model is the one I received on 23/5/12, it could be out of date, so maybe the design has changed significantly? I moved the open half of the castle to close against the other half. Please send me a STEP file of the new design, when appropriate

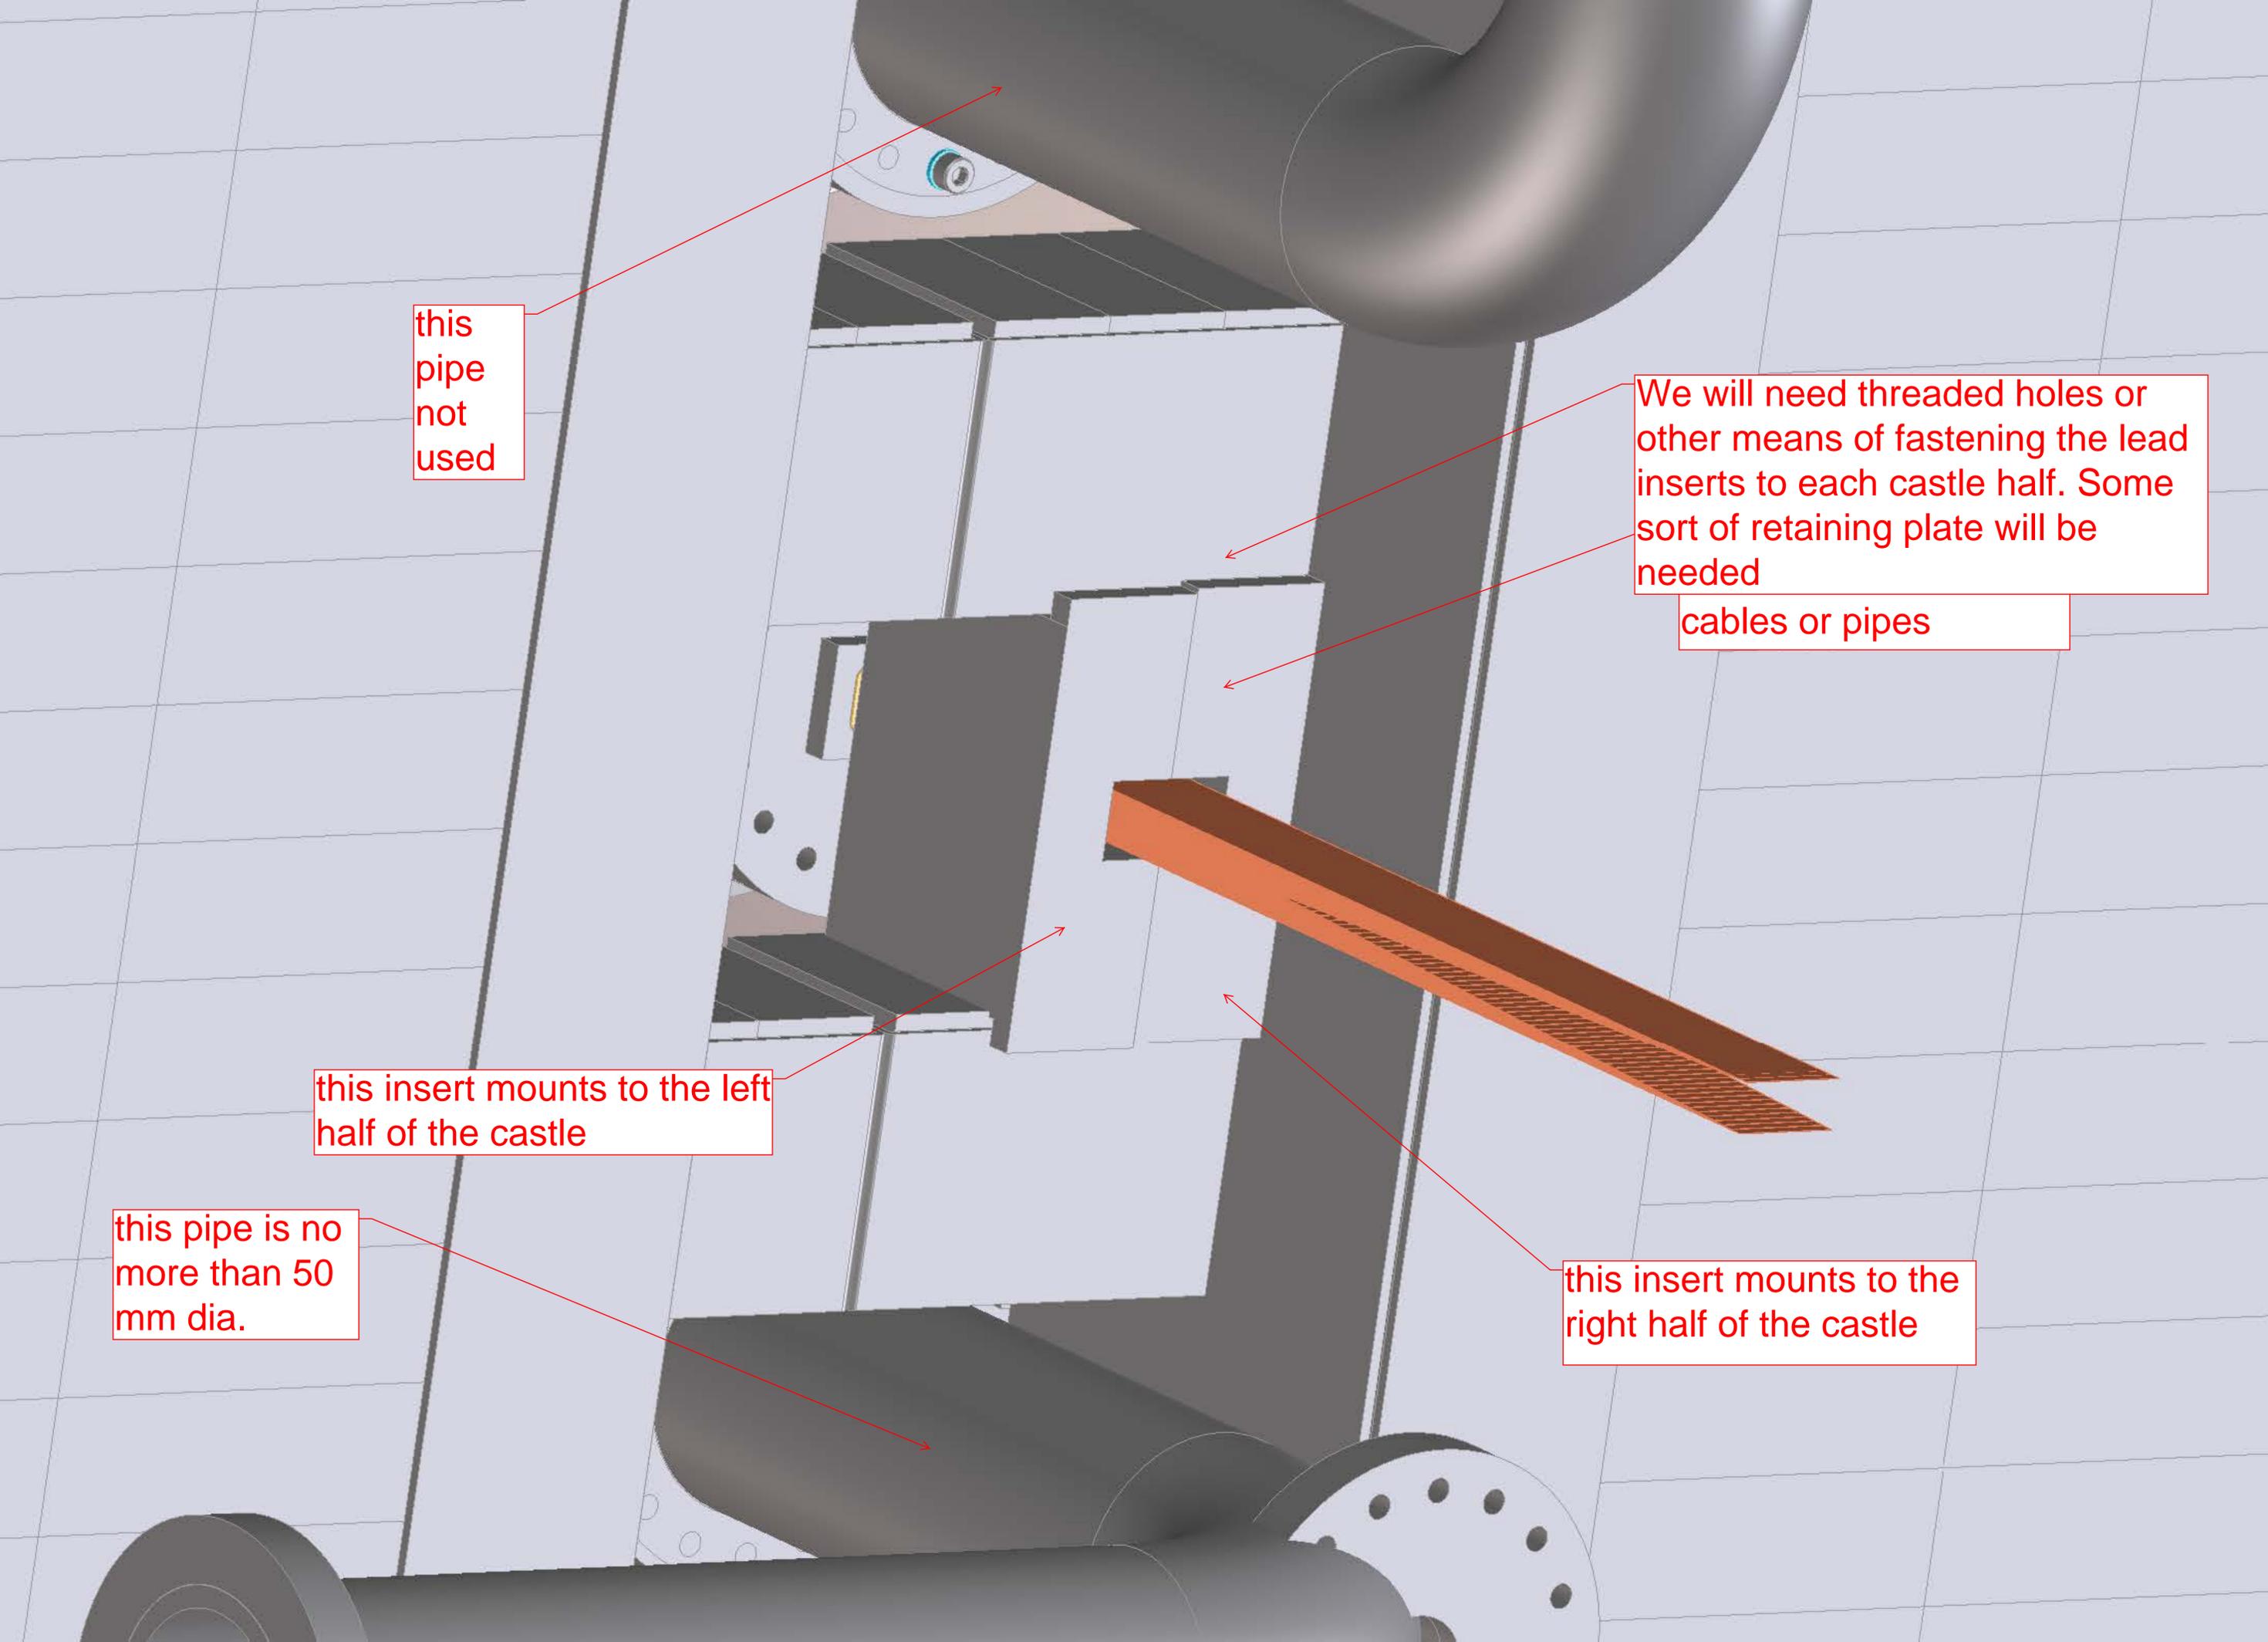
We will need threaded holes or other means of fastening the lead inserts to each castle half. Some sort of retaining plate will be needed

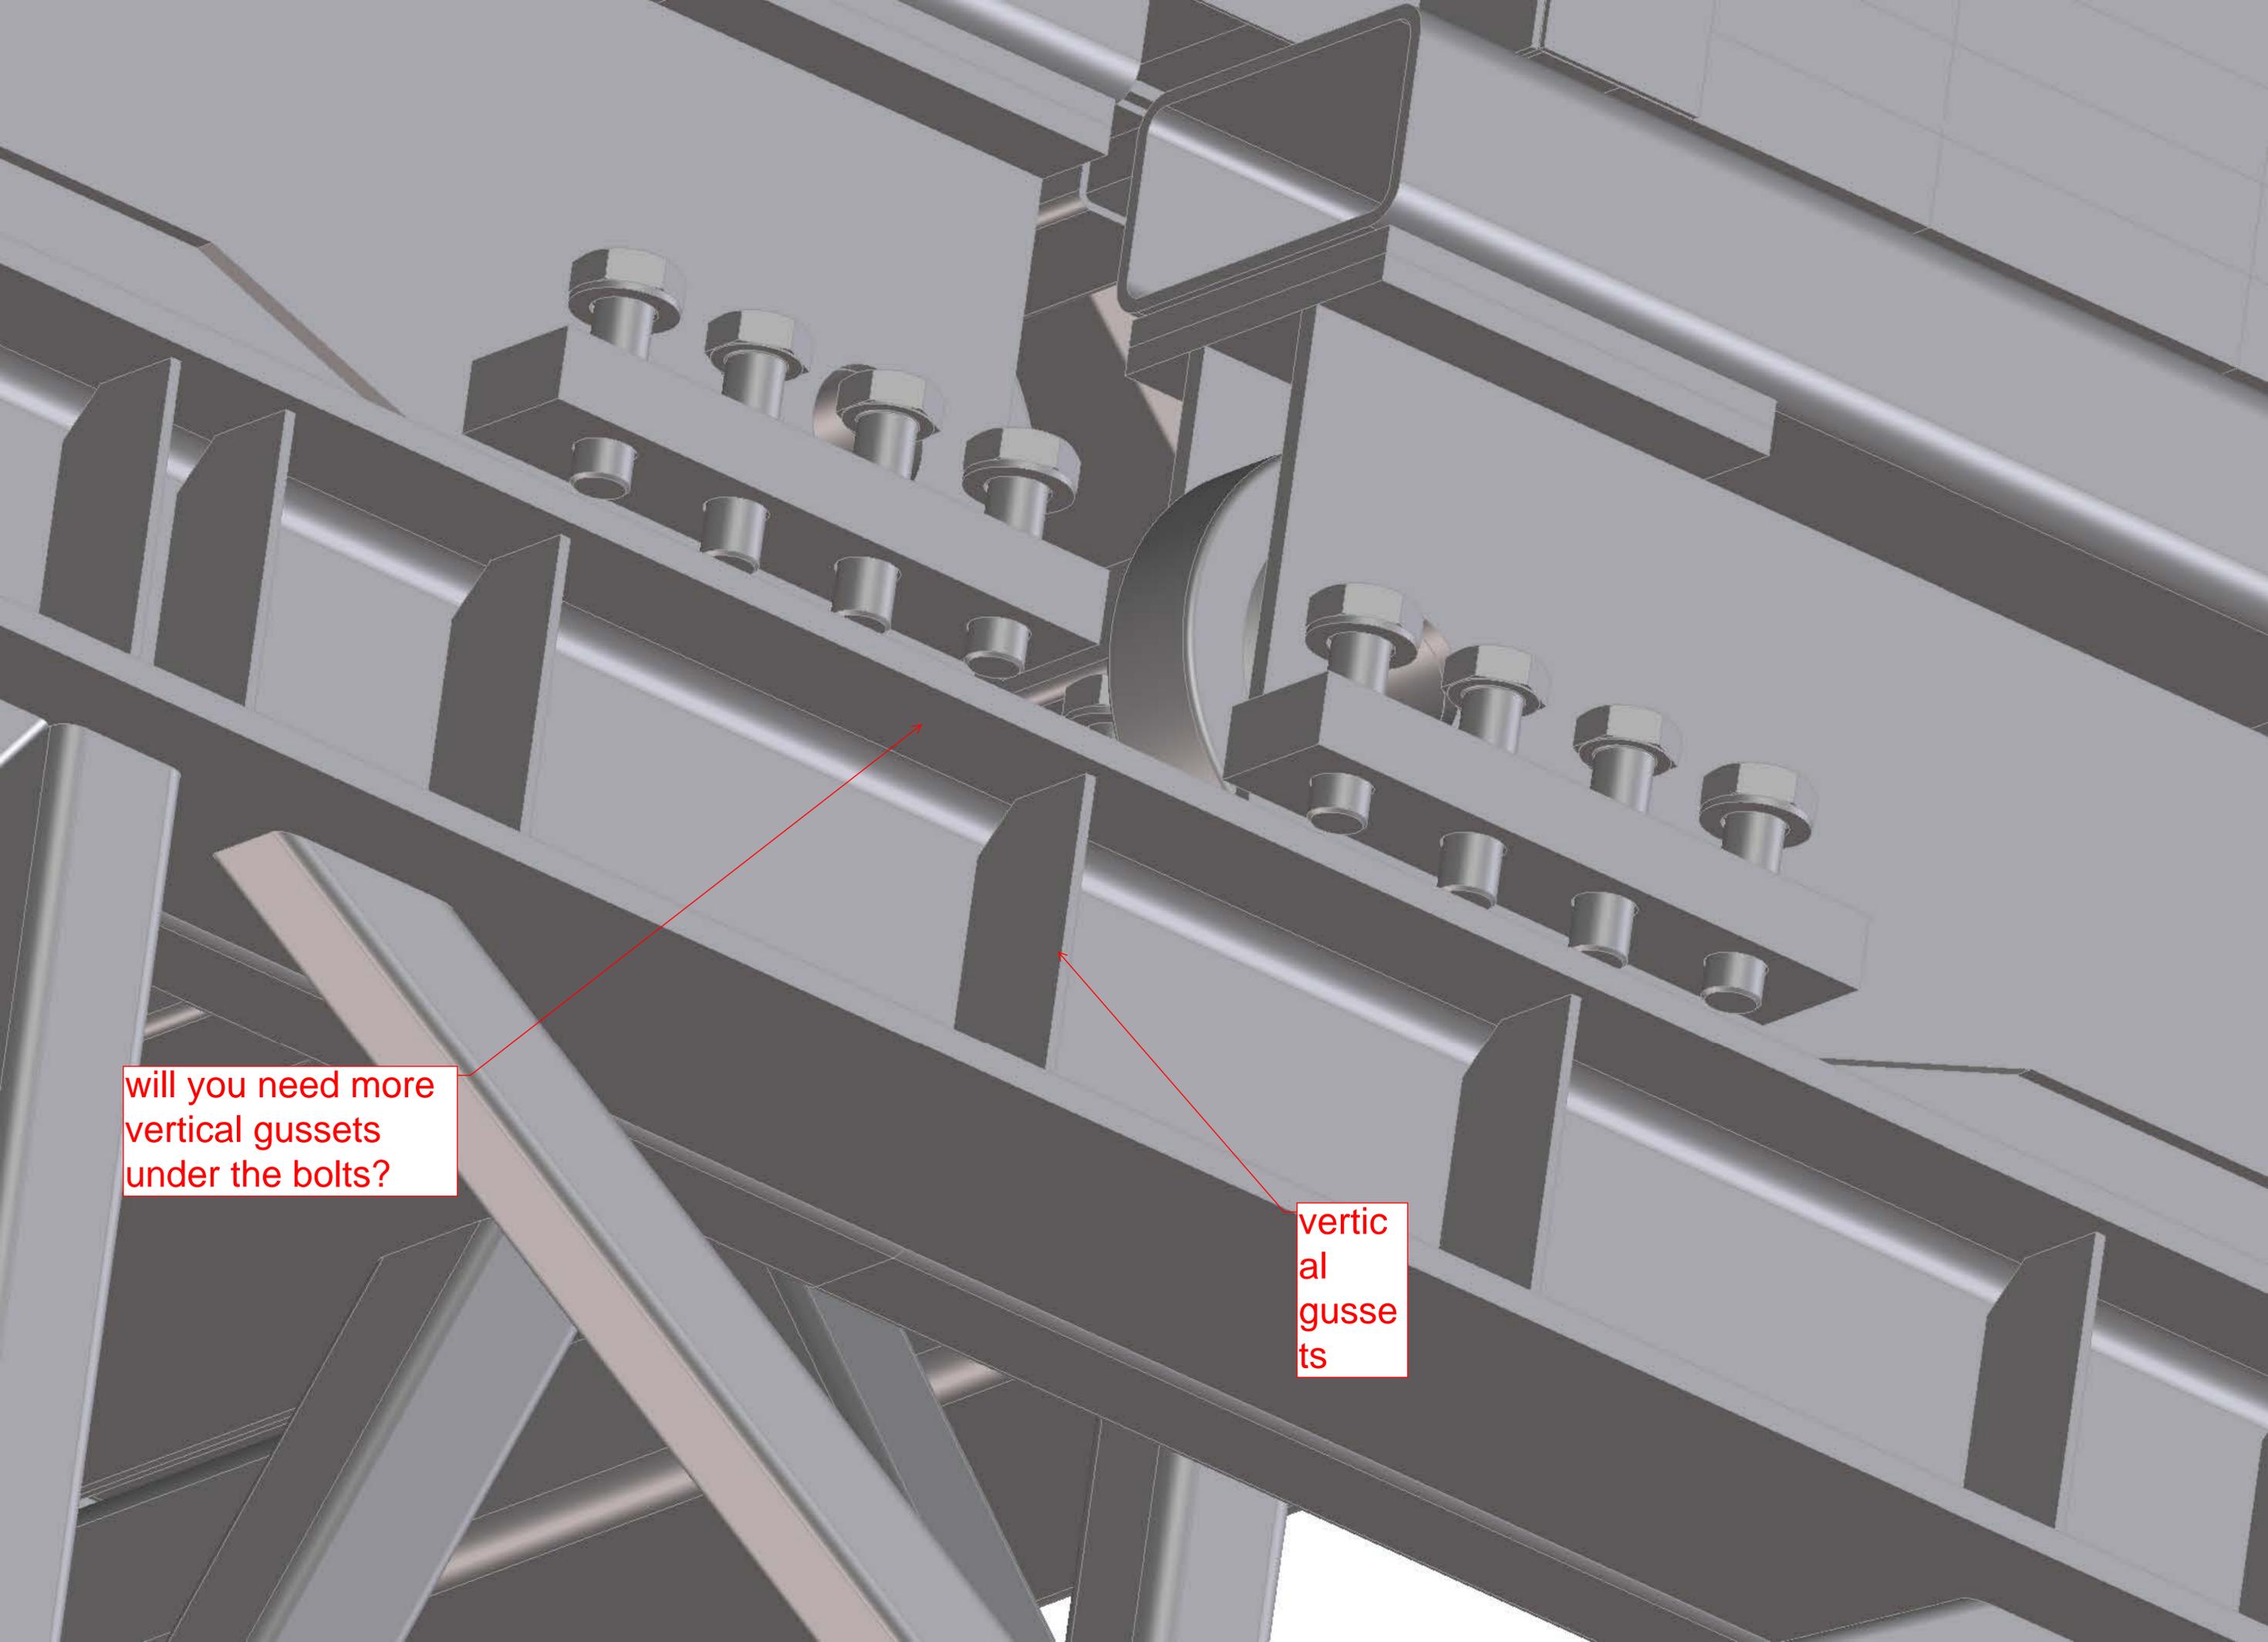
cables or pipes

this insert mounts to the left half of the castle

this pipe is no more than 50 mm dia.

this insert mounts to the right half of the castle

will you need more vertical gussets under the bolts?

vertical gussets
